**STAFF COMMENTS**

**HEARING DATE: September 25, 2025**

B-25:061 — 20 Canada Street, Hamilton

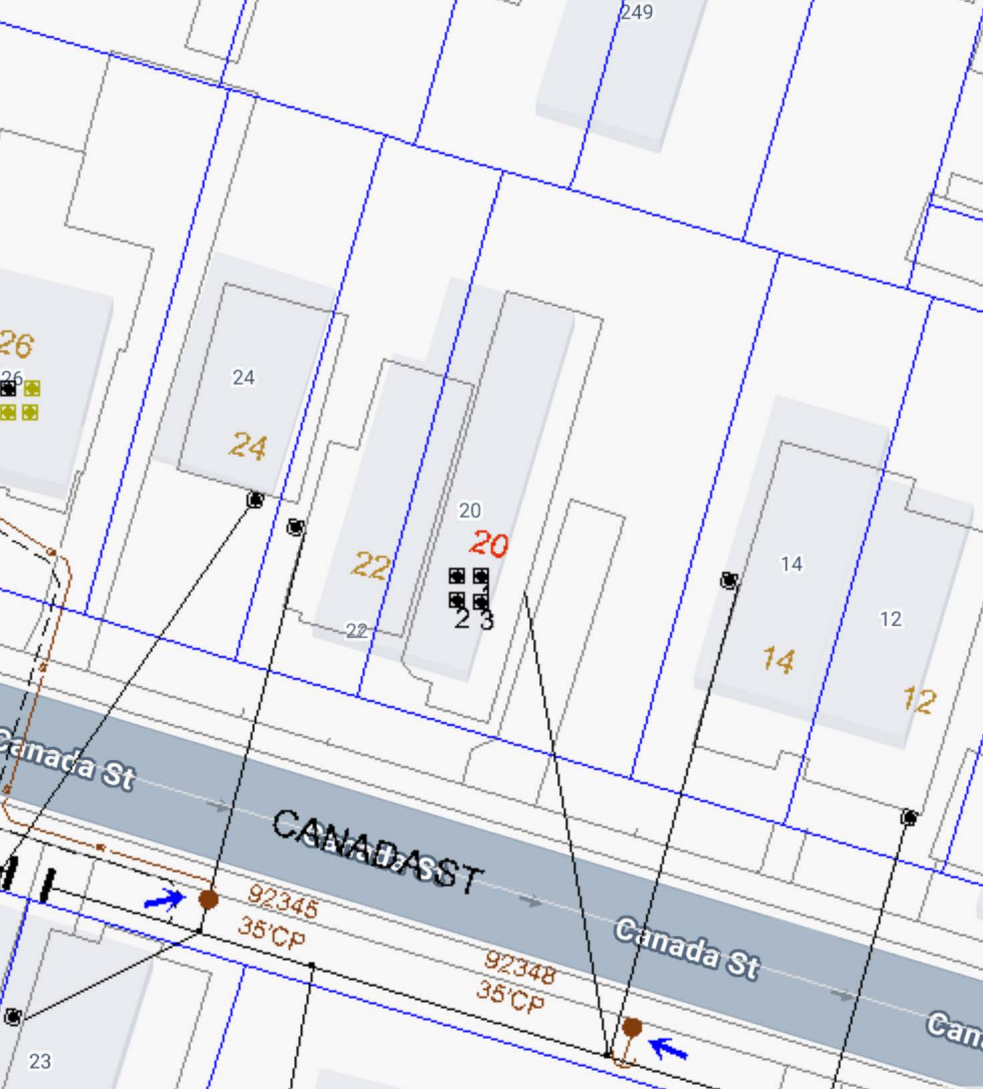
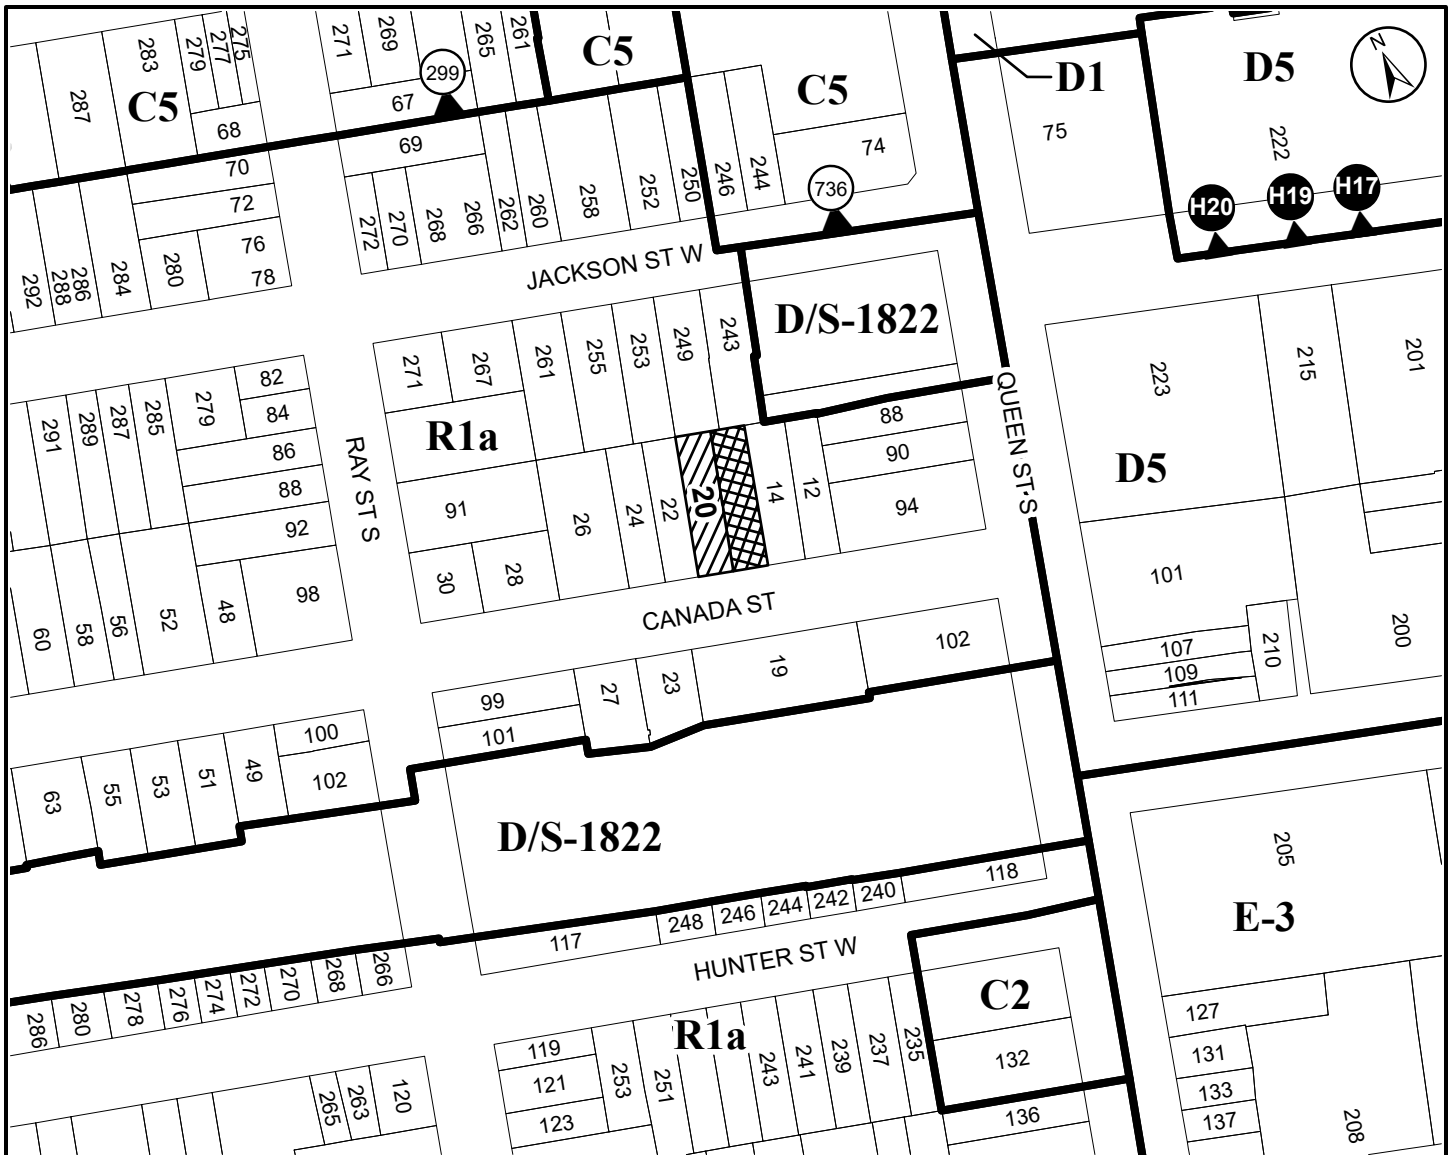
- **Existing O/H secondary service for #20 Canada Street is in conflict with lot severance and building envelope of proposed #20B 3-storey triplex residential building. Existing service must be relocated and possibly conduit altered for a midspan service connection to resolve conflict prior to lot being severed. Contact our ICI Group to discuss existing and new service options.**

- Do not excavate within two metres of hydro poles and anchors.
- Excavation within one metre of underground hydro plant is not permitted unless approval is granted by an Alectra Utilities representative and is present to provide direct supervision. Cost associated with this task shall be at the owner's expense.

- CALL BEFORE YOU DIG, arrange for underground hydro cable locate(s) before beginning construction by contacting Ontario One Call @ 1-800-400-2255.
- Clearances from Overhead and Underground existing electrical distribution system on our adjacent to the property must be maintained in accordance to:

- Ontario Building Code (2024) Section 3.1 (3.1.20.1)
  - Electrical Safety Code Rule 75-312
  - Occupational Health and Safety Act (OH&SA) – Construction Projects (Electrical Hazards)
